V2500 Propulsion System - Nacelle **SERVICE BULLETIN**

Subject: Transmittal of Revision 5 to Service Bulletin Number V2500-NAC-71-0082

NACELLE - POWER PLANT – MOUNTS -
AFT ENGINE MOUNT BARREL NUTS - REPLACEMENT OF

V2500-NAC-71-0082

Removal and Installation of the Aft Engine Mount Barrel Nuts
Figure 1 (sheet 1)

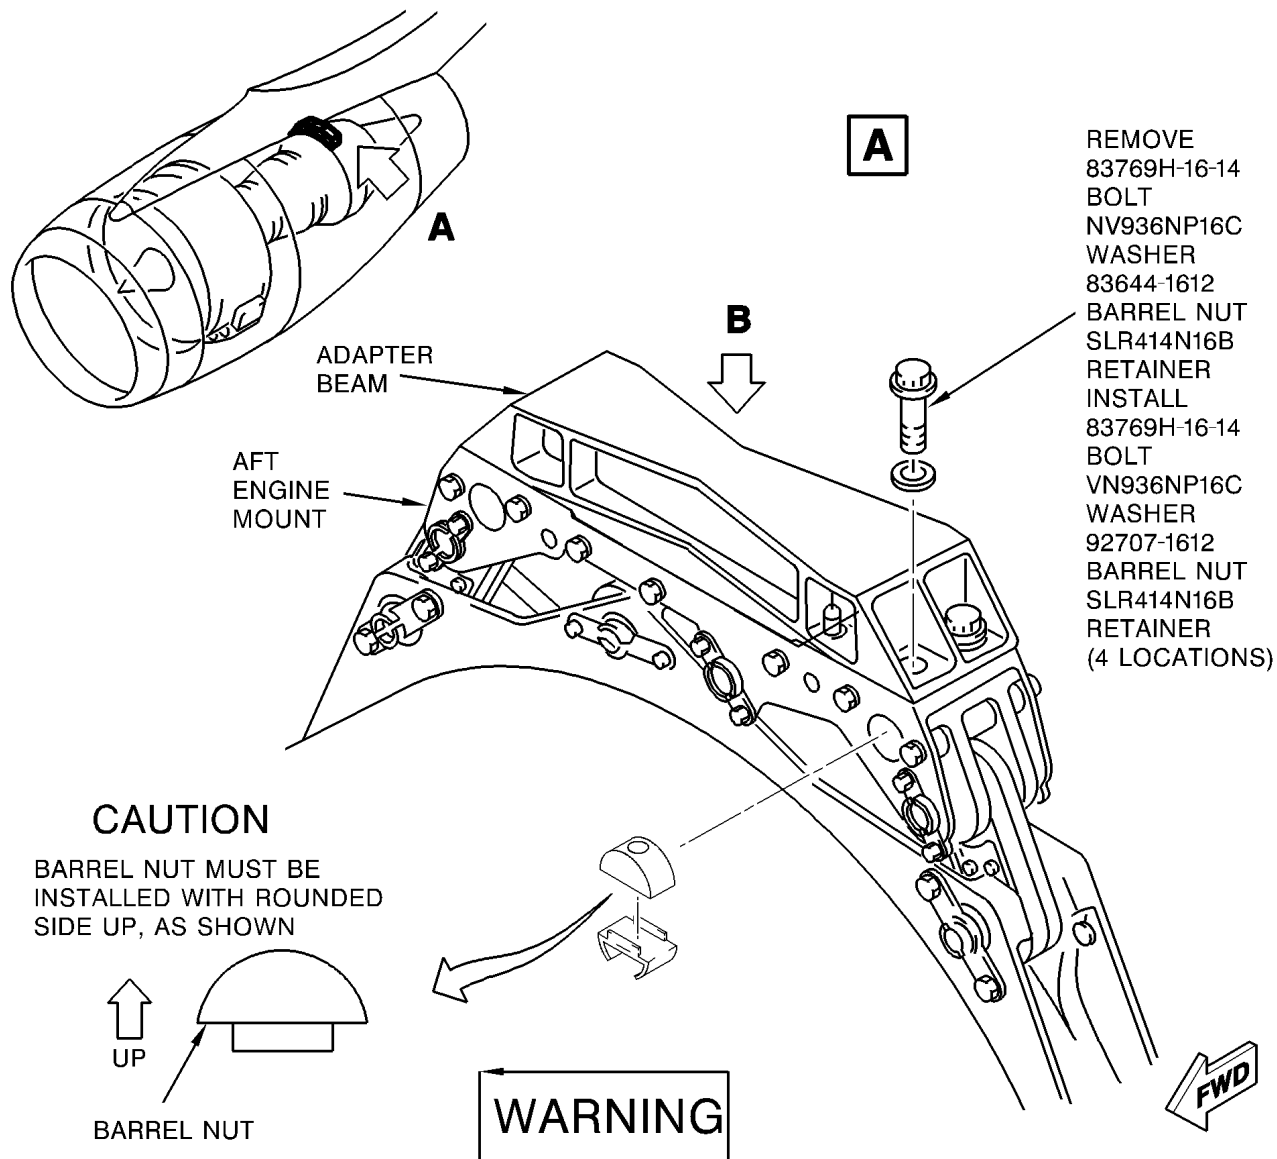
- (1) Open the fan cowl doors as specified in the V2500 Aircraft Maintenance Manual, TASK 71-13-00-010-010.
- (2) Open the thrust reverser halves as specified in the V2500 Aircraft Maintenance Manual, TASK 78-32-00-010-010.
- (3) Find the aft engine mount assembly on top of the engine (Refer to Figure 1).

- (2) Remove barrel nuts as follows (Refer to Figure 1):
 - (a) Remove one only 83769H-16-14 bolt, VN936NP16C washer, 83644-1612 barrel nut, and SLR414N16B barrel nut retainer from aft engine mount.
 - (b) Identify the nut with the engine serial number code and nut position number on the end opposite the 'X' mark.
 - 1 The engine serial number code is the last three digits of the engine serial number.
 - 2 The nut position number is the position of the indicator based on the following scheme:
 - (c) Retain bolt, washer, and retainer. Return the nut to Rohr. See paragraph 2.C..
